DEPARTMENT OF HOUSING AND COMMUNITY DEVELOPMENT 2021 Virginia Uniform Statewide Building Code Base Document

9/28/2021

Summary – This document is compiled by staff of the State Building Codes Office of the Division of Building and Fire Regulation. Its purpose is to convert the 2018 USBC to the 2021 USBC by comparing the language in the 2018 USBC to the 2021 editions of the International Codes and standards which have amendments in the USBC. It is not intended to create substantive changes to the 2018 USBC. Those differences between the 2018 International Codes and standards and the 2021 International Codes and standards which are not affected by existing state amendments to the 2018 International Codes and standards are not addressed in this document. Those differences may be addressed in the full code change process for the 2021 USBC. The base document is simply to make those necessary changes to the 2018 USBC to bring in the 2021 International Codes and standards and keep the existing state amendments which were made to the 2018 International Codes and standards. If the 2021 International Codes and standards have language that is consistent with an existing state amendment to th

Figure R301.2(5)A ULTIMATE DESIGN WIND SPEEDS 8. Change Figure R301.2(5)B to read:

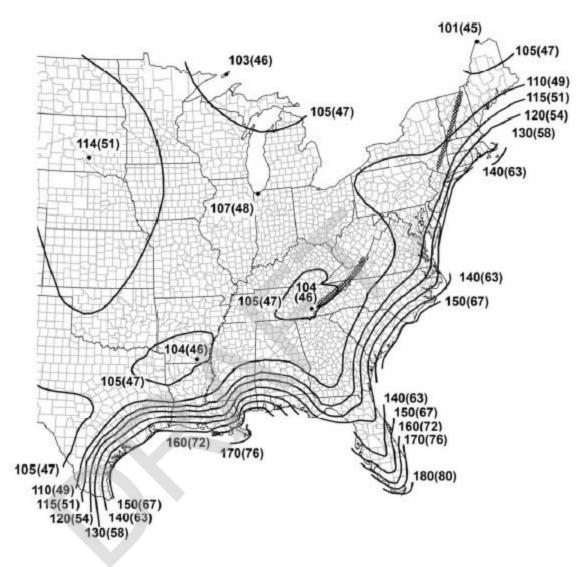
7. Change Figure R301.2(5)A to read:

Note: Crosshatching on map indicates Special Wind Region

Figure R301.2(8) COMPONENT AND CLADDING PRESSURE ZONES

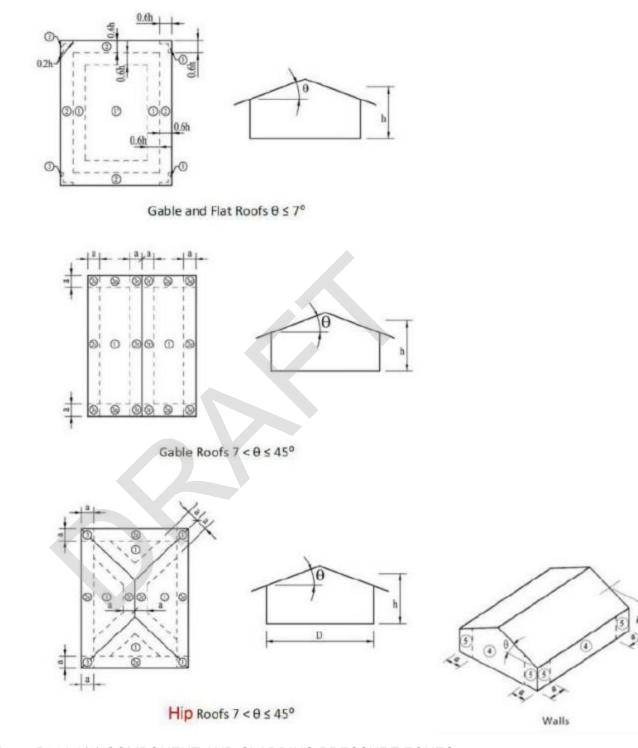
Figure R301.2(5)B REGIONS WHERE WIND DESIGN IS REQUIRED 9. Change Figure R301.2(8) to read:
